From: Lauren Balisky
Sent: Wednesday, November 17, 2021 8:35 AM
To: 'SYLVIA S KAWABATA'
Cc: permittech; Linda Ritter; Garrett Jensen
Subject: RE: Harbor Grove Subdivision Prelim Plat
Attachments: Notice of Application.pdf

Comments in Response to Proposed Development by SEAPAC Homes at 9110 53rd Ave. W, Mukilteo, WA 98275. Dated November 26, 2021.

Comments on Planned Development by Sea Pac Homes at 9110 53rd Ave. W Mukilteo, WA 98275. Dated November 30, 2021

Figure 2 – Areas of 35-40% slopes

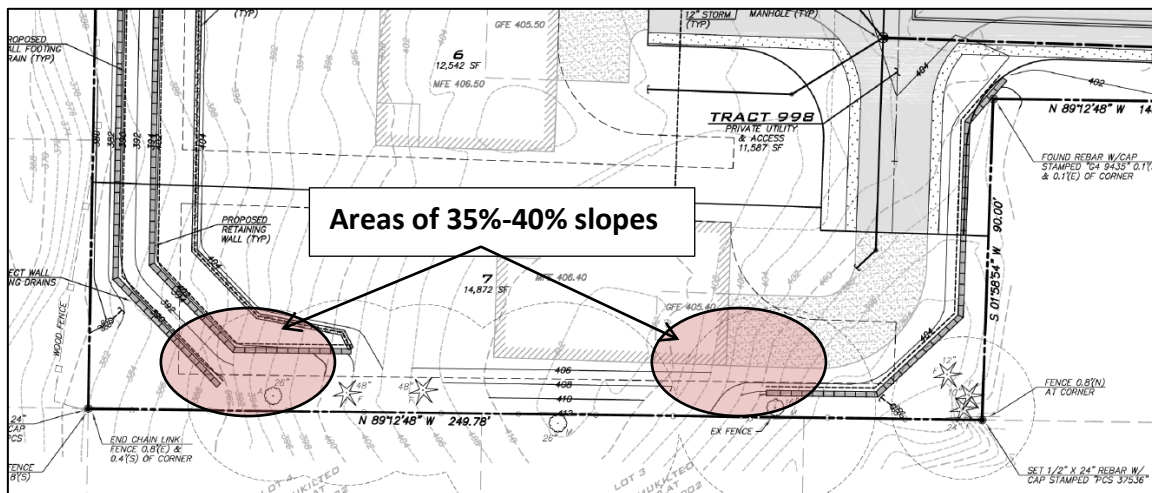
2. Groundwater/Hydrology Study. The need for a groundwater/hydrology study is further supported by the following:
 - A. 15.16.050.C.2.b.i.(b), which requires a slope and hydrology report when clearing/grading on slopes greater than 35%. The south and southwest portions of the site contain slopes greater than 35% (see Figure 2 below from Grading Plan, Sheet 5). I calculated slopes up to 40%.
